ZONING CHANGE REVIEW SHEET

CASE: C814-2017-0001 – 425 W. Riverside PUD

ADDRESS: 425 W. Riverside Drive

ZONING FROM: CS-1-V-NP **TO:** PUD-NP

EXHIBIT C - LAND USE PLAN

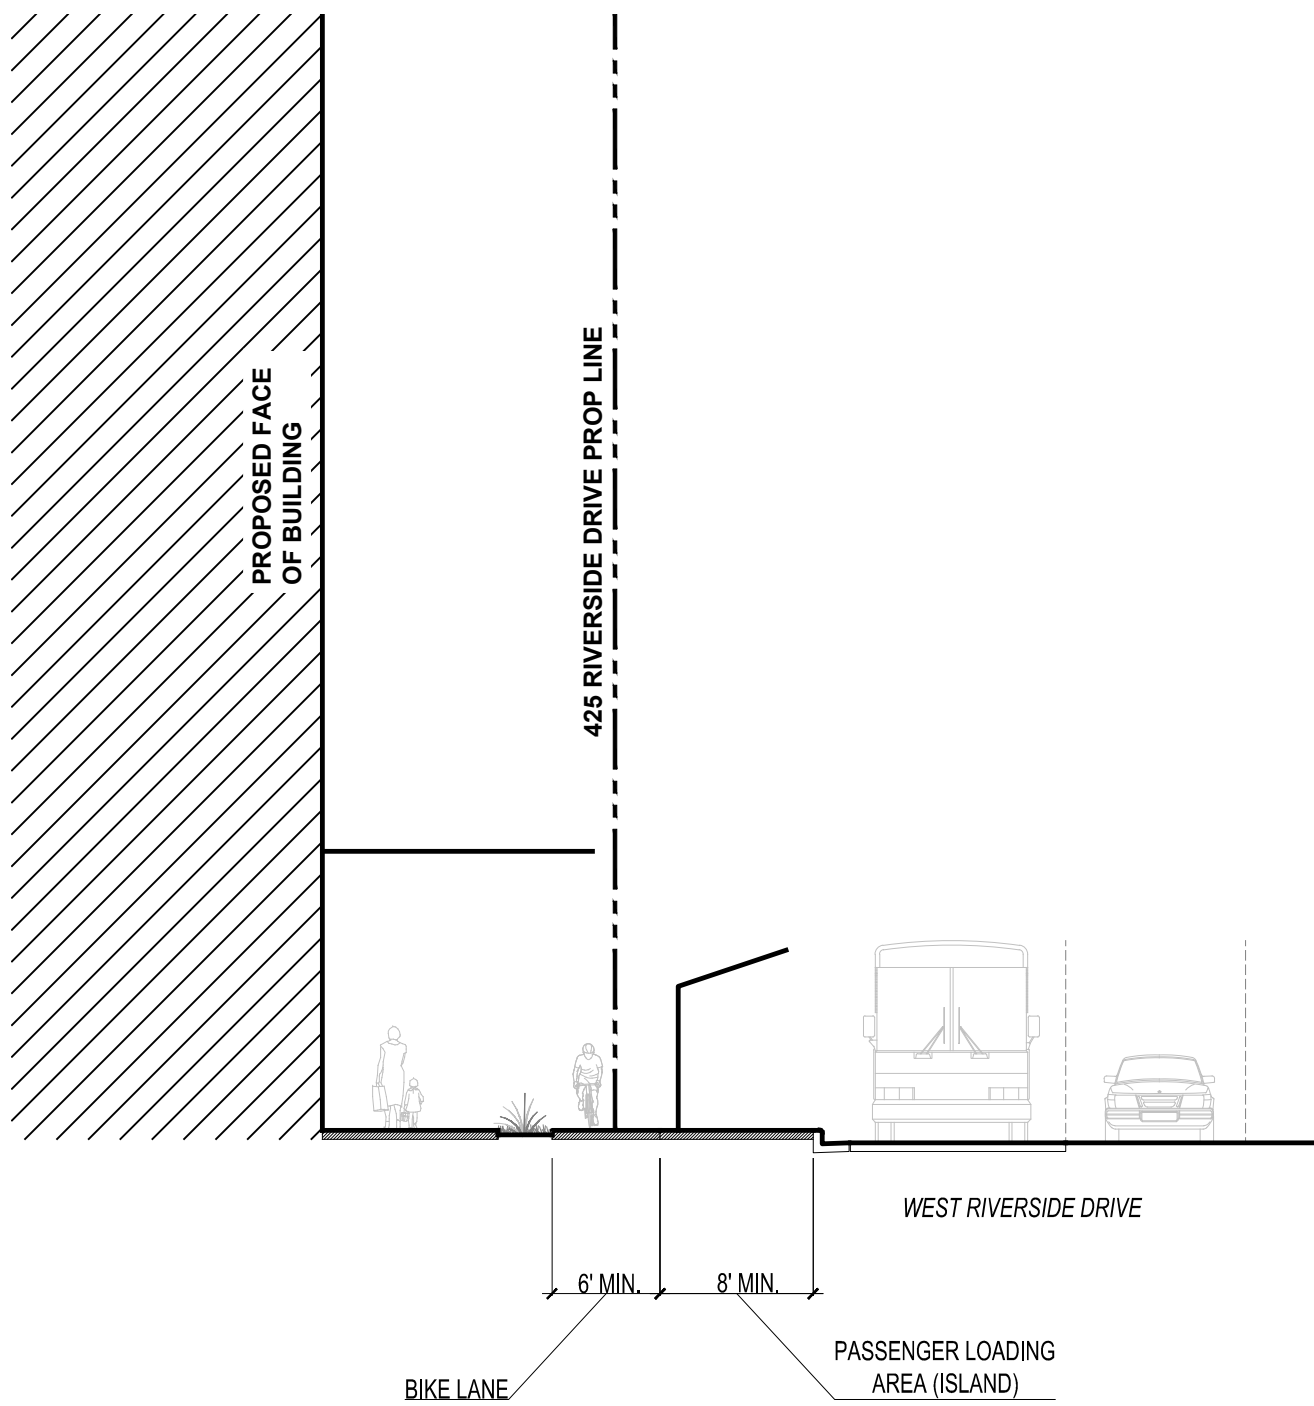
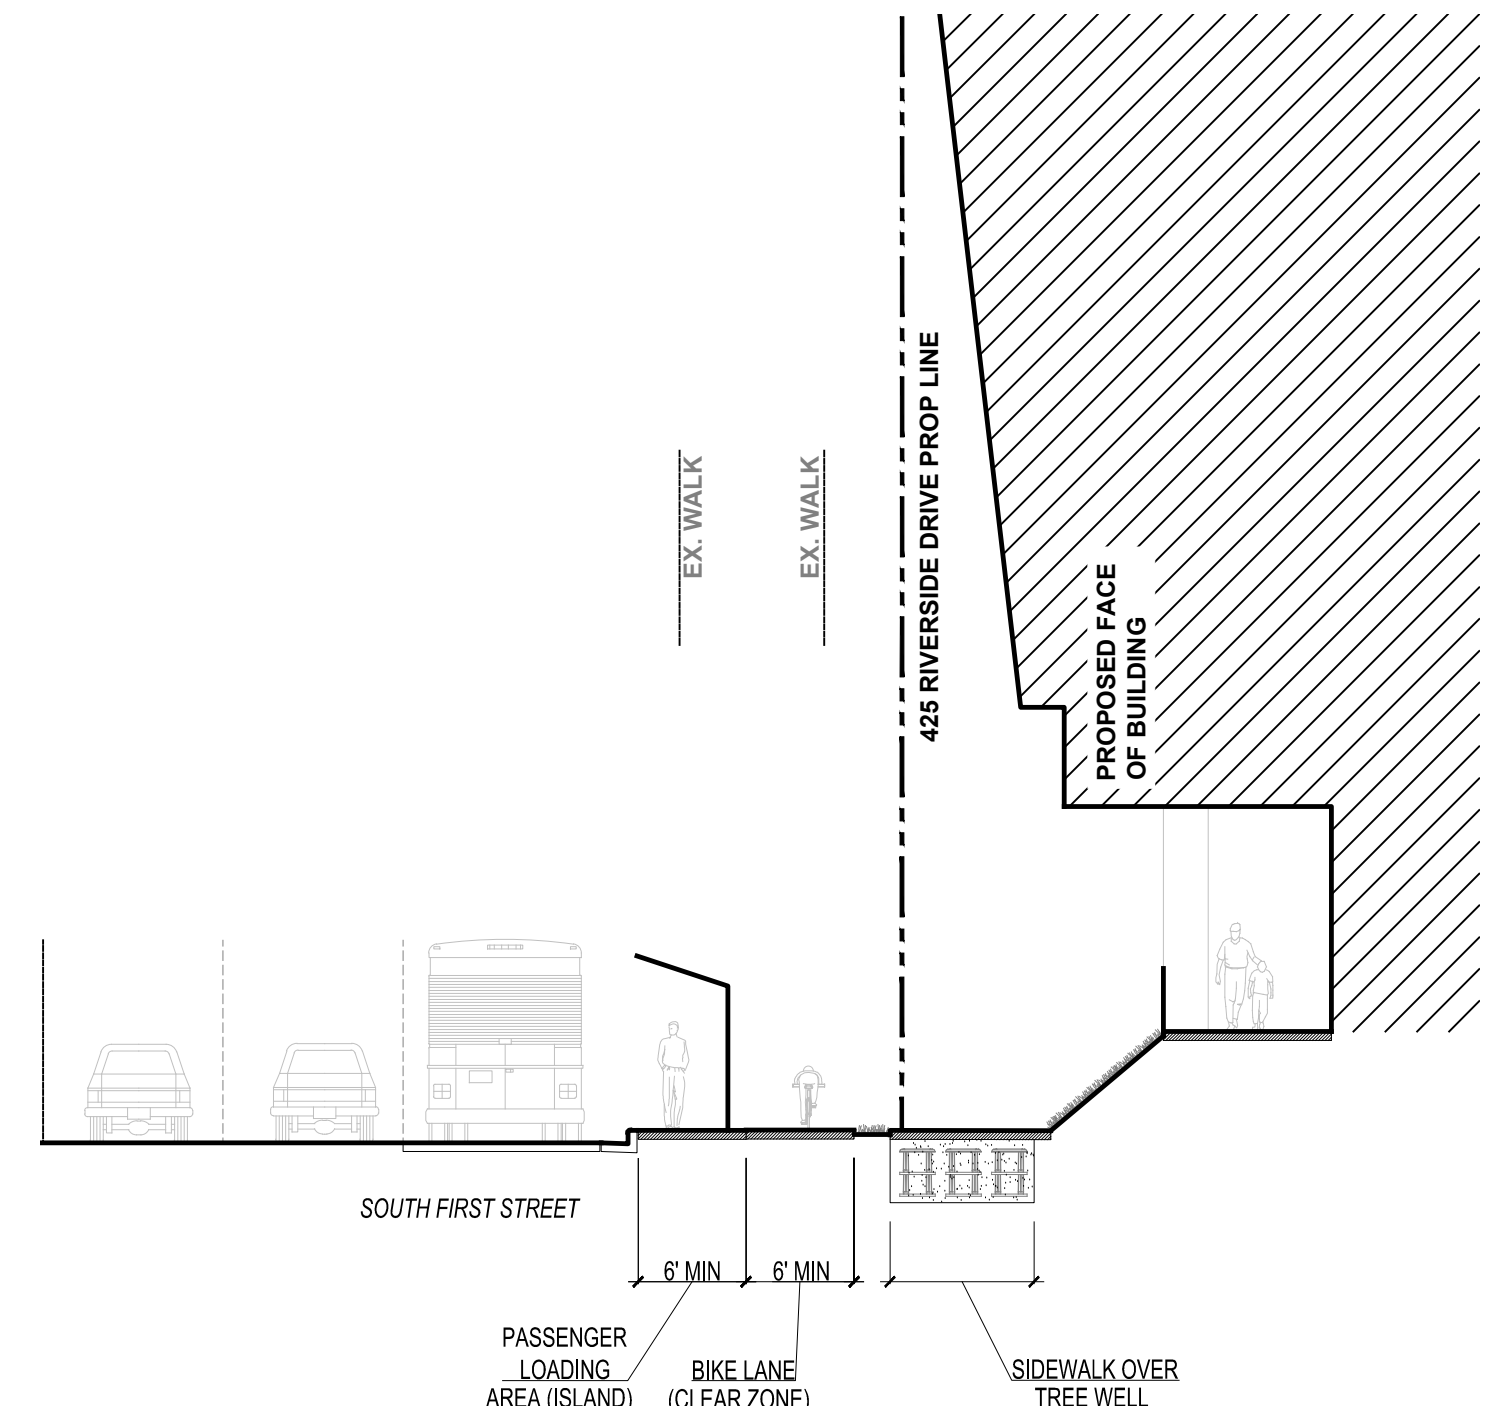
- #1 Corner radiuses: I’m OK with the 25’ radius representation on the land use plan – Exhibit C under the assumption that these show effective radiuses and that details of ADA ramp and bikeway configurations and actual curb radiuses will be decided at site plan (while conforming to the effective radius.

- #2 On exhibit C, note 4 should be removed. In the above comment we need to retain the ability to design the corners and bikeway interactions at site plan. A single curb ramp is not preferred from an pedestrian / bicycle design and may not align with ADA requirement / best practices.

EXHIBIT E

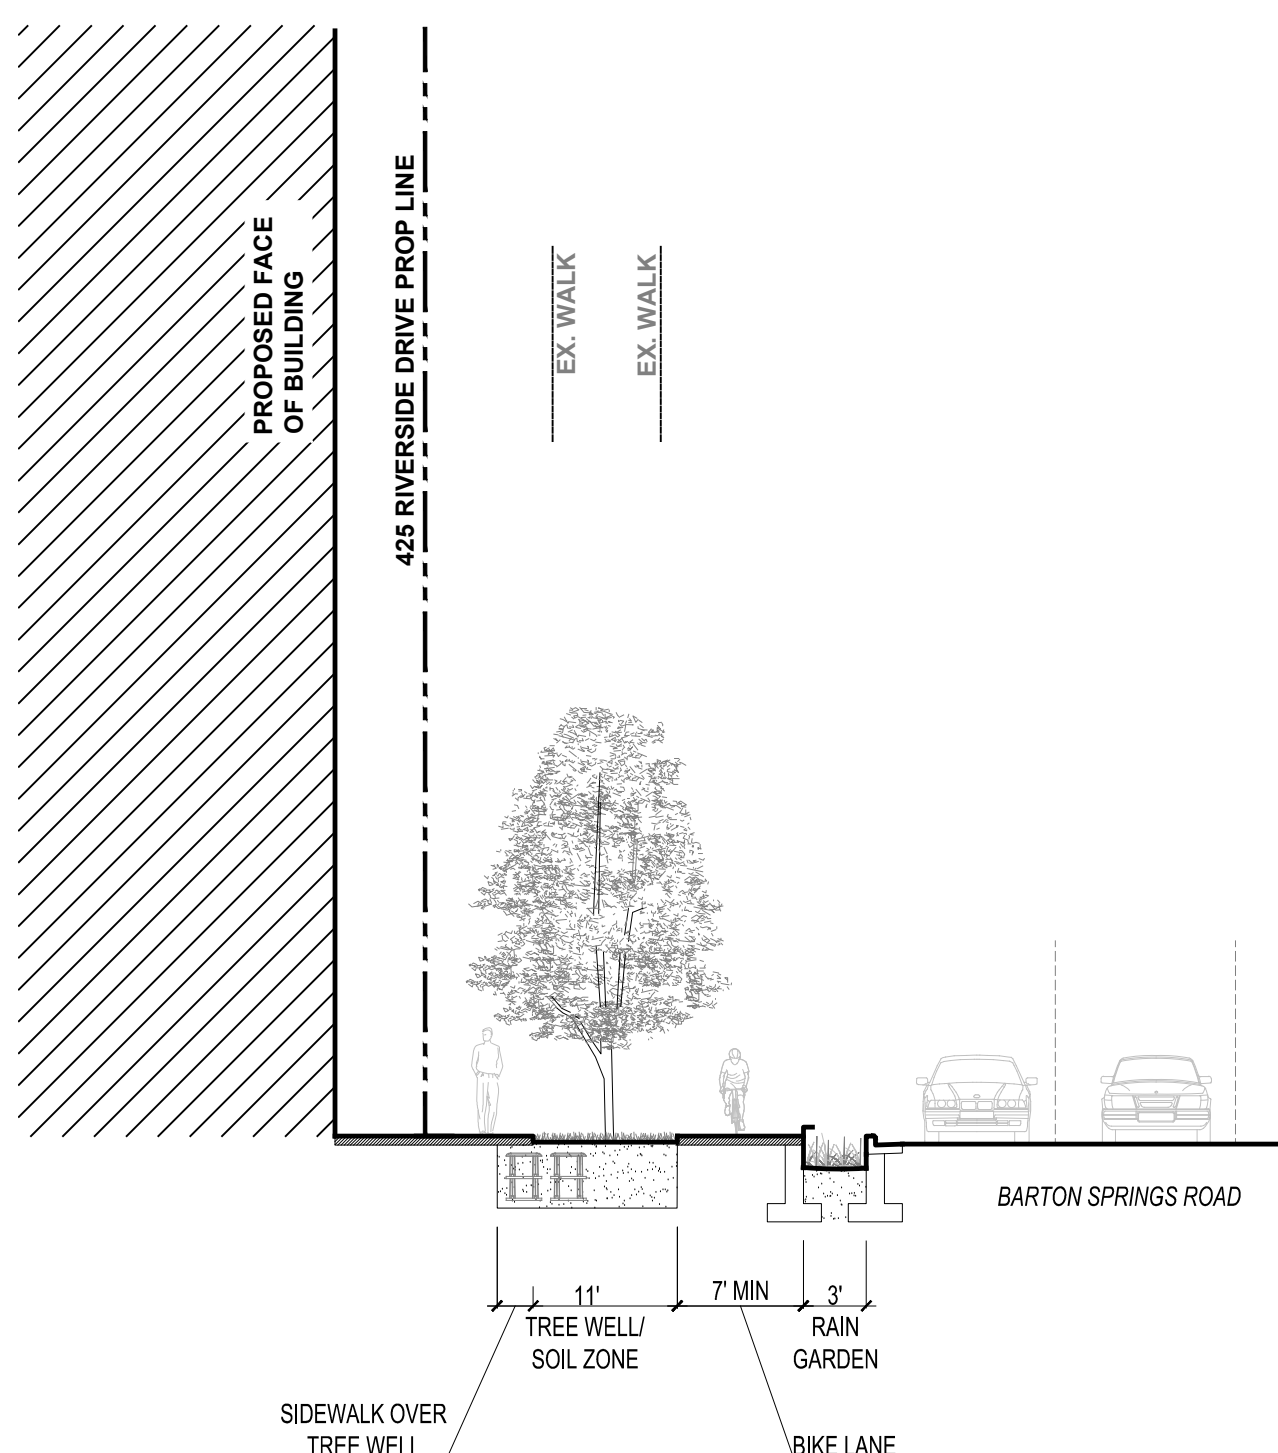
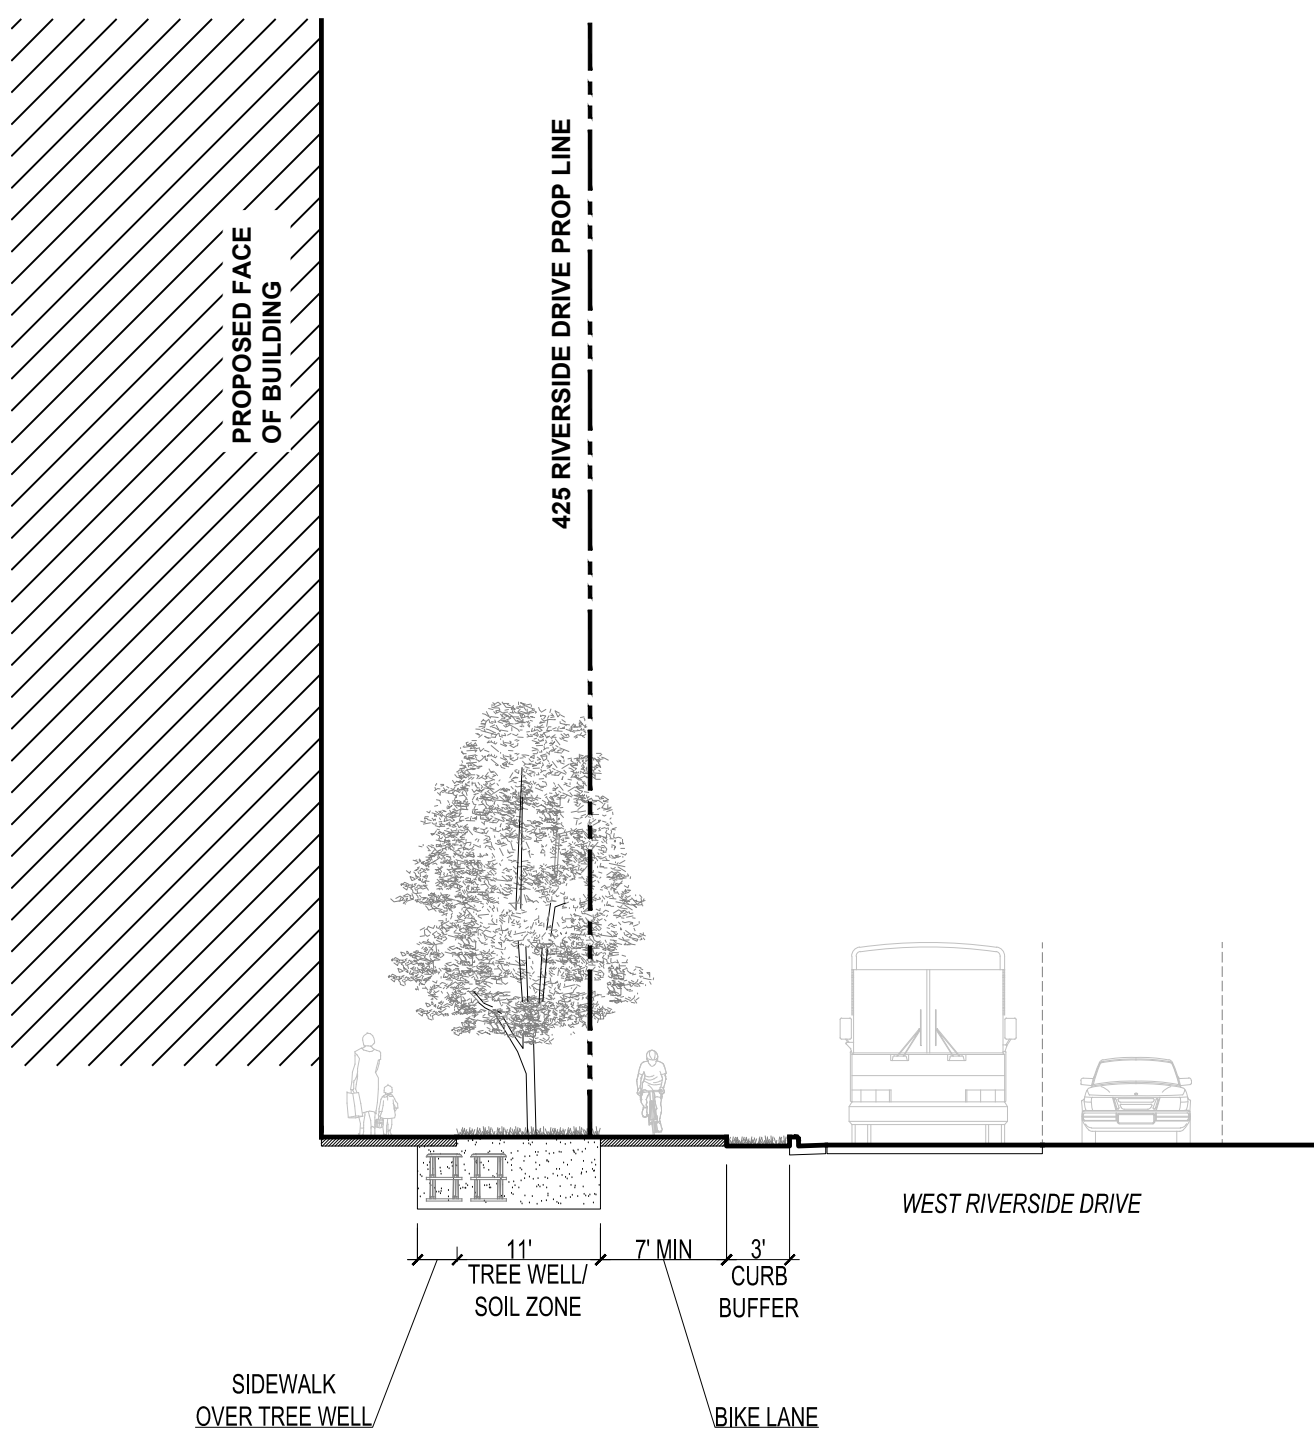
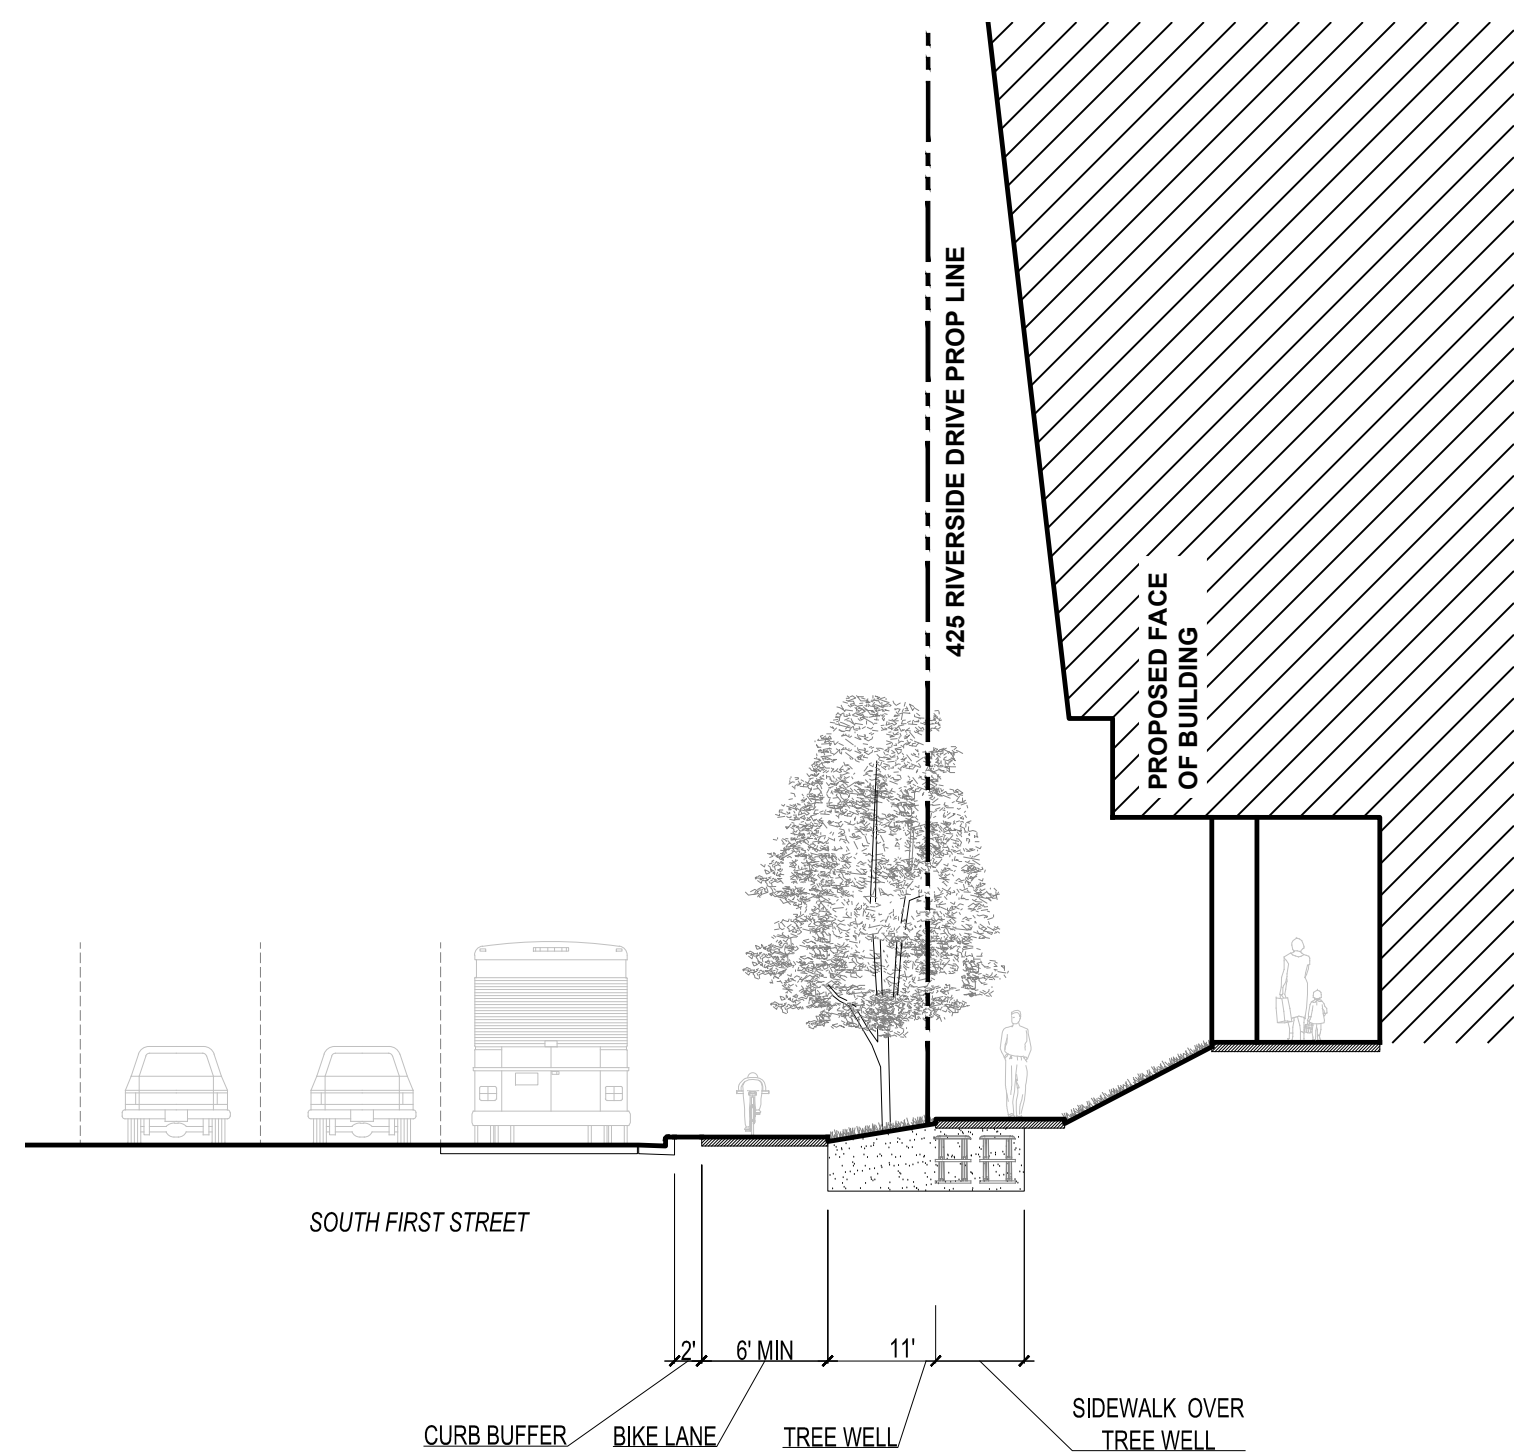
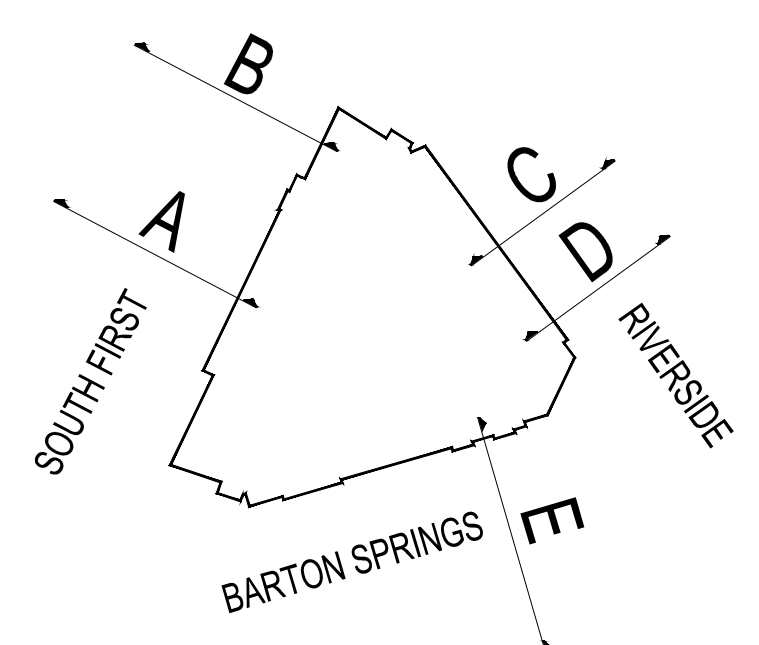
- #3 Bicycle Lane Width - the bicycle lane widths do not conform to the original drawing I sent in May. In the attached Exhibit C and E I have marked up width changes. In short the following are the dimensional requirements for the bicycle lane in a few scenarios:
If pavement on either side of bicycle lane is not rideable than 7' is the minimum bikeway dimension.

If there is a dropoff into a rain garden there needs to be a hand rail that is recessed from the bike lane by 6" as to not encroach in the bicycle lane space (handrails should be added to relevant cross sections in exhibit E. If there is rideable pavement on both sides of the bike lane the minimum acceptable dimension is 6'
